**BEFORE COMMISSIONERS APPOINTED BY
THE CANTERBURY REGIONAL COUNCIL**

Under proposed Plan Change 5 to the Canterbury Land and Water
Regional Plan

**BRIEF OF EVIDENCE OF WILLIAM HENRY SUTHERLAND FOR
BENMORE STATION LIMITED**
22 July 2016

Appendix 1

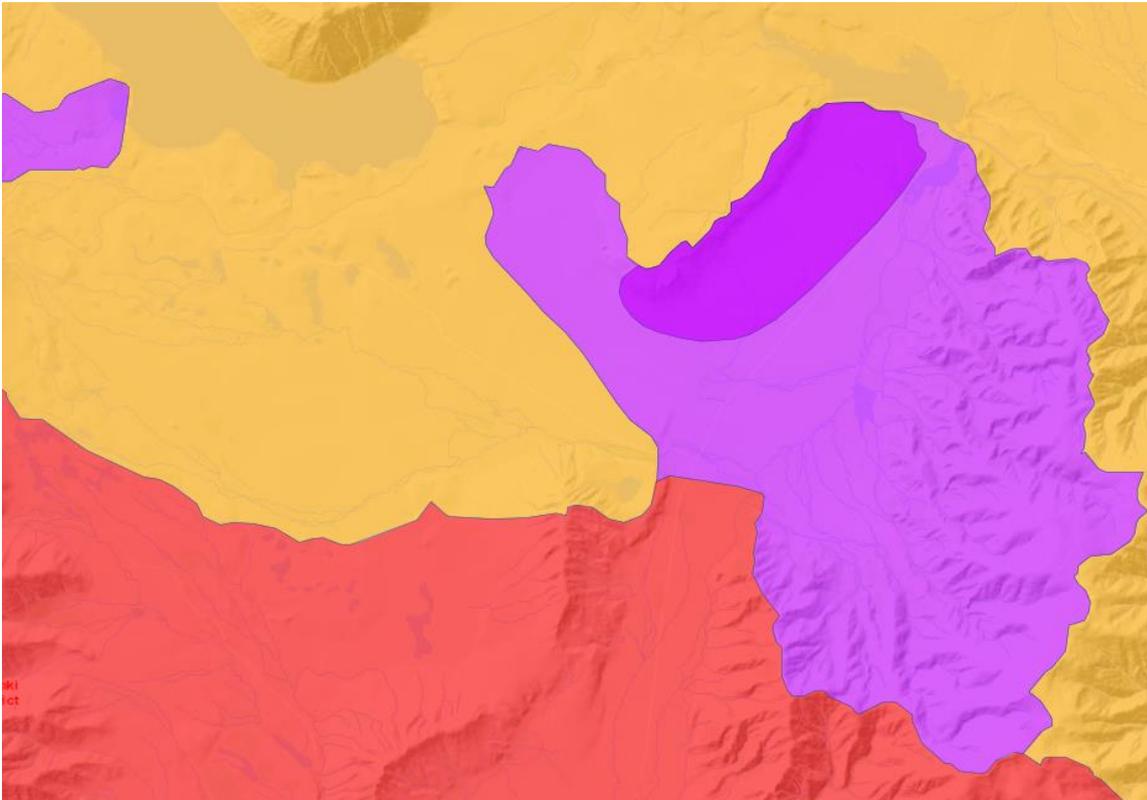
- 5 There is a proposed change to map PC5-17 which changes the majority of the western part of Benmore Station from orange to red (the change is shown in **Appendix 1**, against the current Land and Water Regional Plan map).

- 7 The new map wholly attributes flows from this area to the Ahuriri catchment (red zone), and based on my direct knowledge of the catchment flows, I consider this to be incorrect.

- 8 When water flows under the bridge on the Ohau Road, there is no physical way it can ‘turn back’ and flow into the Ahuriri catchment. The only direction for water flowing under the bridge is to the north, where it gathers water volumes as the Wairepo makes its way back to the Wairepo Arm, before entering Lake Ruataniwha.

- 9 Accordingly, Environment Canterbury are wrong to attribute all flows to the Ahuriri.

- 10 I accept that during low flows, water does not flow under the bridge. Therefore, during low flows, the water follows the stream under our house, to the south, and then make their way to the Ahuriri catchment.
- 11 However, the large catchment run-off issues occur during floods and freshes, and in that instance, the path of the water changes to the north.
- 12 It might be an issue where the area identified as changing on the planning maps needs to have a different colour that is not wholly red or wholly orange. I strongly oppose it being attributed as being fully within the Ahuriri/red zone, and I suggest that it is in the Council's interest to correctly design the catchment flows for a start, before determining the 'colour' and rules attributed to the catchment area.

18 I consider that the planning maps should be amended in accordance with the information that has been outlined above.
